Site Plan Drawing_V2.pdf Markup Summary

VENETUCCI FARMS

A PORTION OF THE SW $\frac{1}{4}$ OF THE SW $\frac{1}{4}$ OF SECTION 11 AND A PORTION OF THE NW $\frac{1}{4}$ OF SECTION 14, EL PASO, COUNTY
 5202 HWY 85-87, 5210 HWY 85-87, 5304 HWY 85-87 & 5304 HWY 85
SPECIAL USE PERMIT - BUSINESS EVENT CENTER

PPR 21-053
 AL 21-015

COVER SHEET

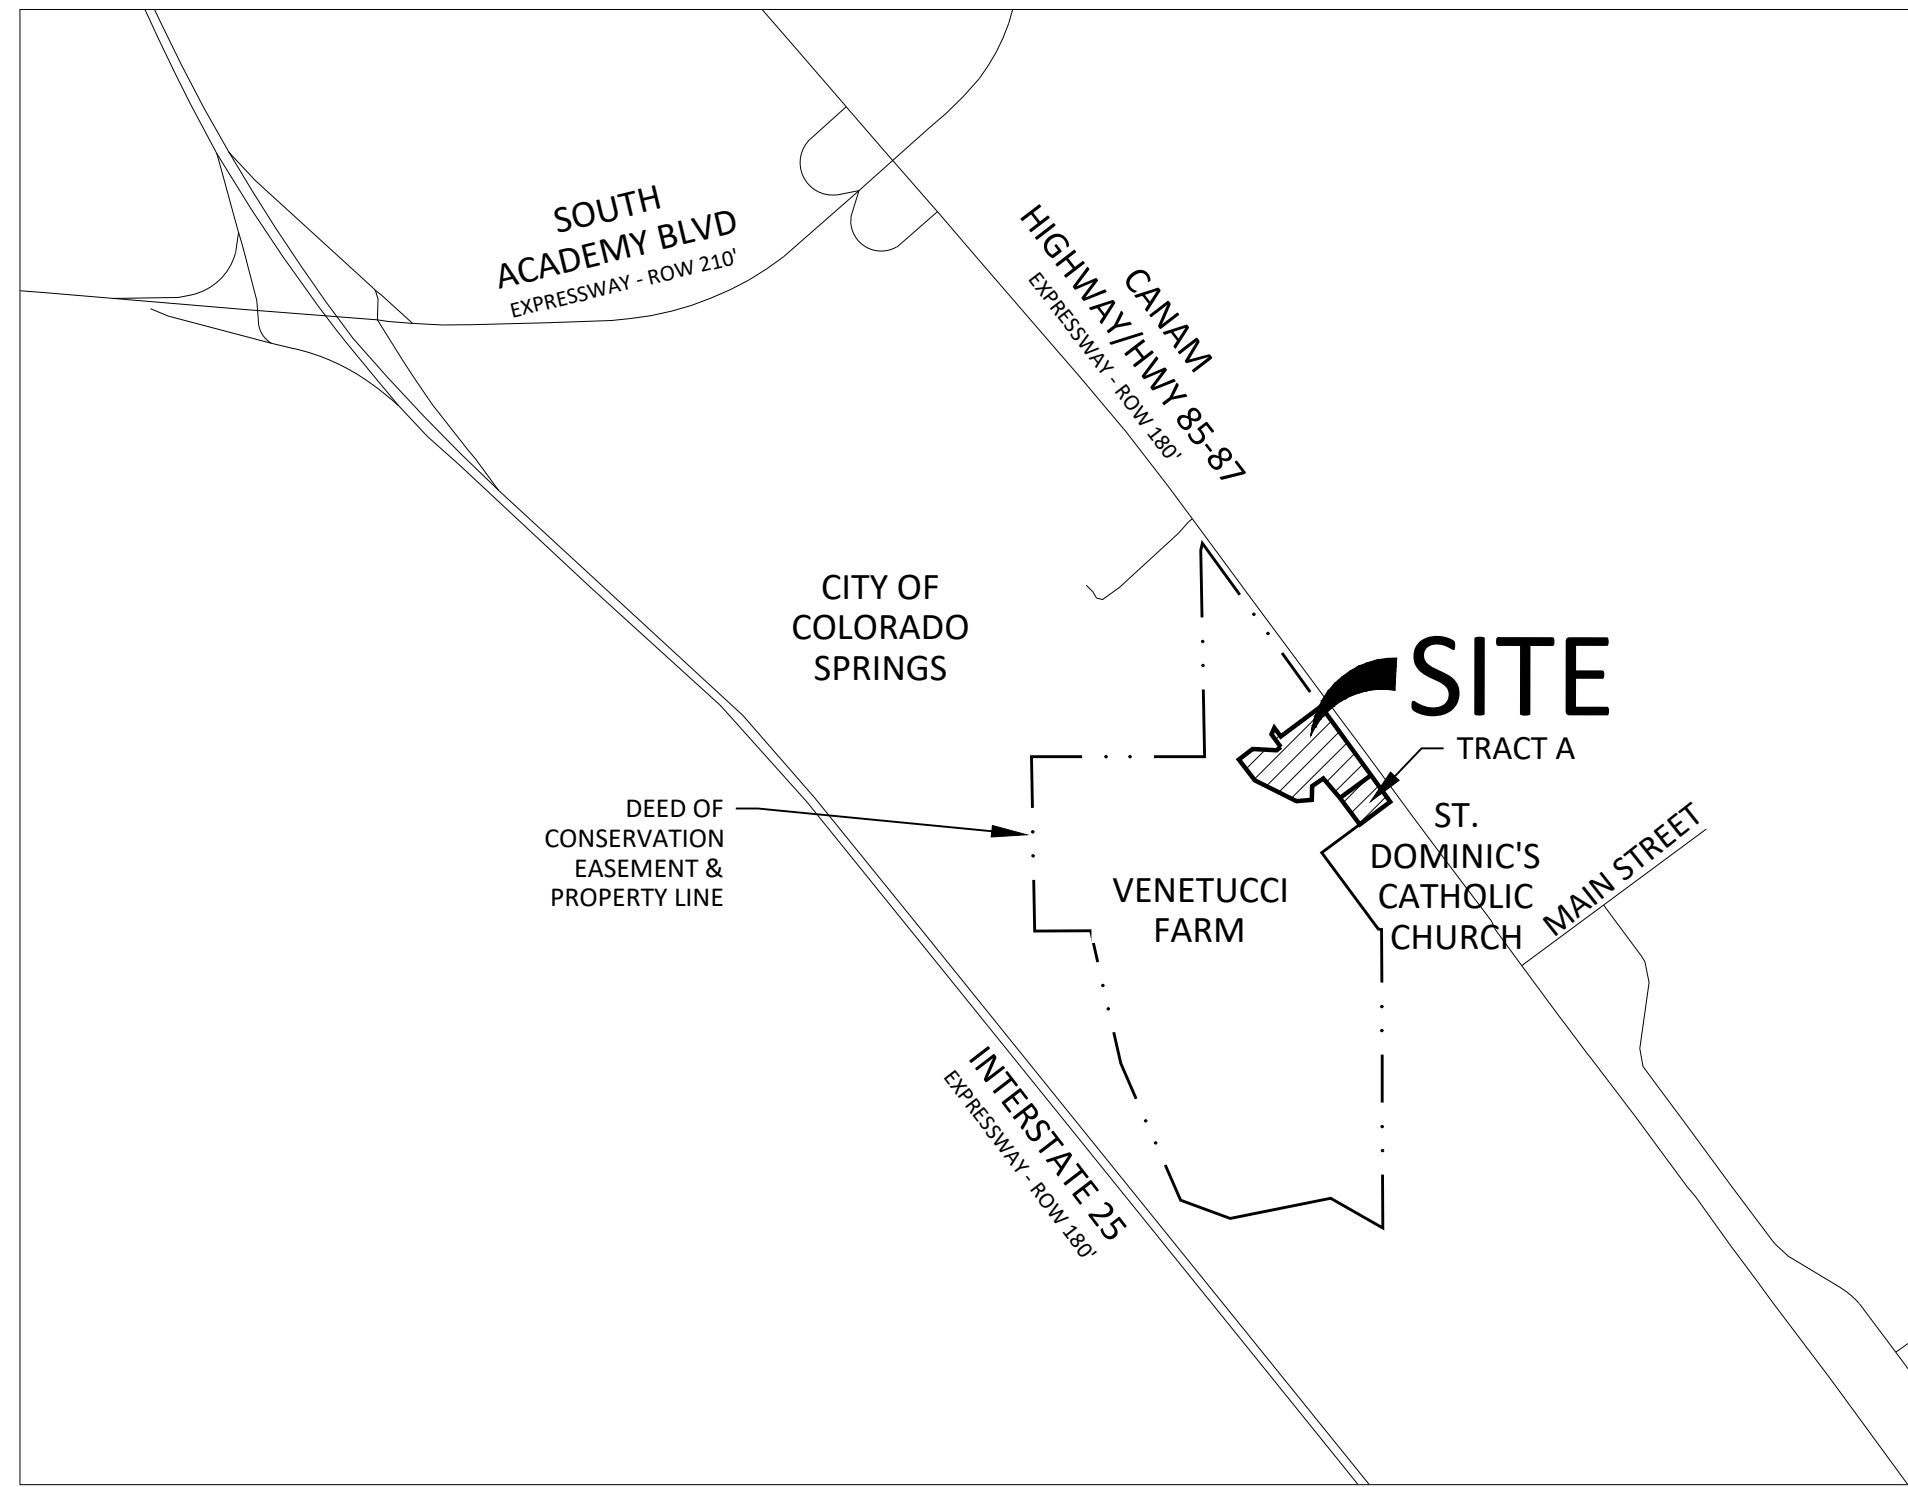
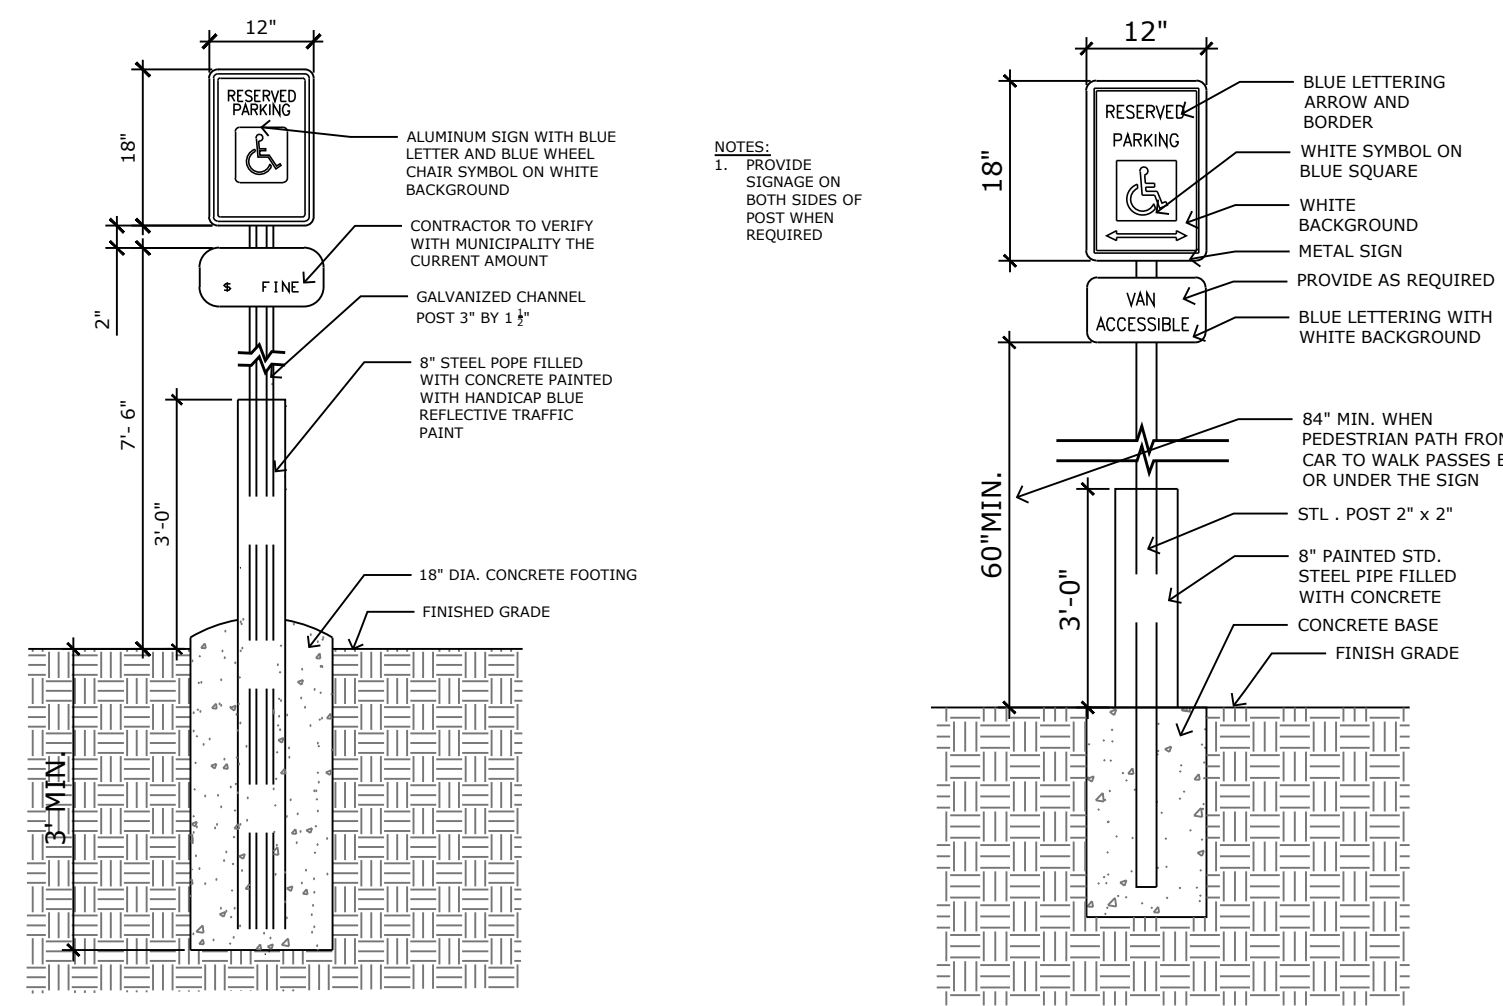
Only 3 ADA parking spaces shown on plan. Please revise. The site plan has been revised to show 4 ADA parking spaces

Include percent of open space, landscaping and lot coverage on plan. This has been added.

SITE PLAN

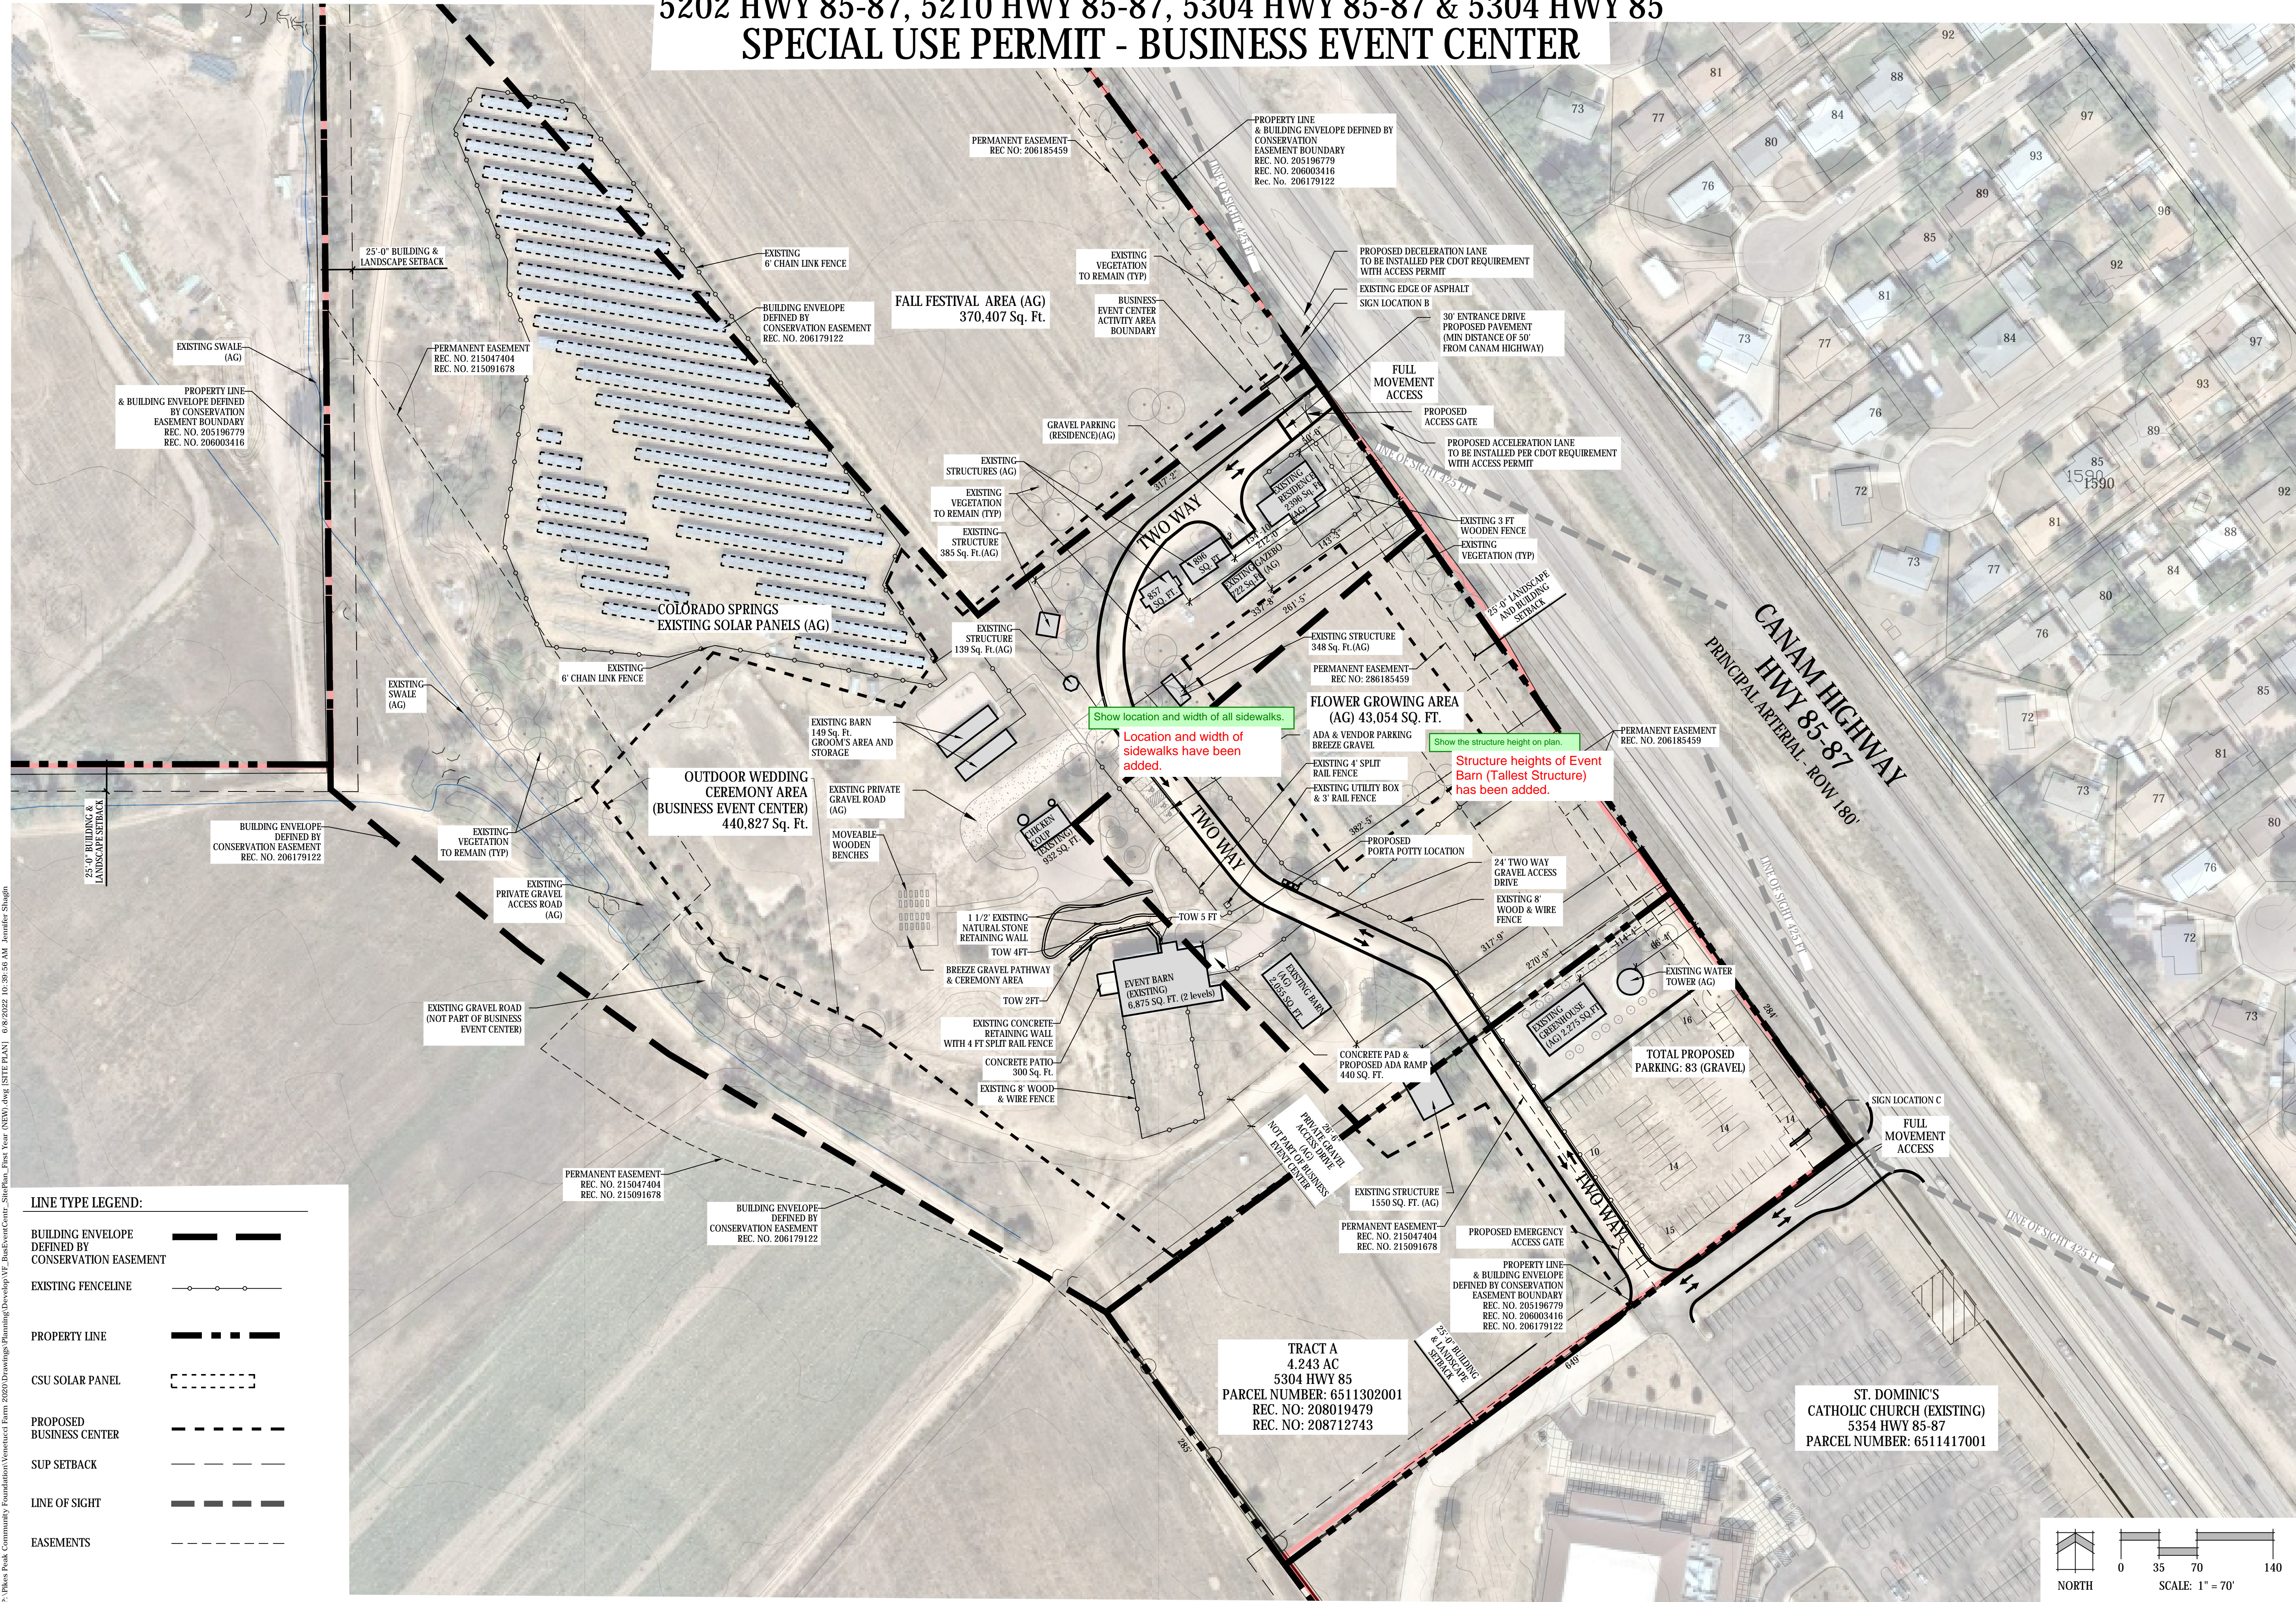
Show the structure height on plan.

Show location and width of all sidewalks.
